802.3dj D1.0
Comment Resolution - Electrical track
Adee Ran, Cisco

Introduction

- This slide package was assembled by the 802.3dj electrical editorial team to provide background and detailed resolutions to aid in comment resolution.
- Acknowledgement to Howard Heck, Adam Healey, Chris Diminico, Mike Dudek, Matt Brown, and Kent Lusted for reviewing and contributing to this work.
- Text in red indicates editors' explanation of the comments. Italics indicate an editor's observation which might be subjective.
- The responses to the comments may point to the slides for reference but the comment report is the official record.

Figure 176E-2—Components of a 200 Gb/s per lane AUI-C2M interface and insertion loss budget at 53.125 GHz

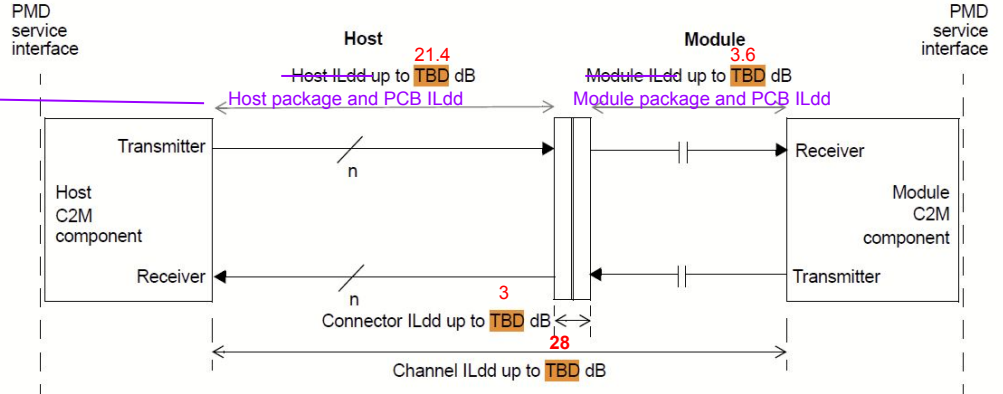
CI 176E SC 176E.4.1 P632 L6 # 73

The IL_dd for AUI C2M channel is a TBD

The referenced presentation is https://www.ieee802.org/3/dj/public/24_01/lusted_3dj_03_2401.pdf. The comment is against 176E.4.1 (Recommended channel characteristics/Insertion loss), which has an equation for the ILdd limit. The suggested remedy does not address the equation. The proposed value for this TBD (Channel ILdd) is **33 dB**. Comment #134 suggests **28 dB** for the same TBD.
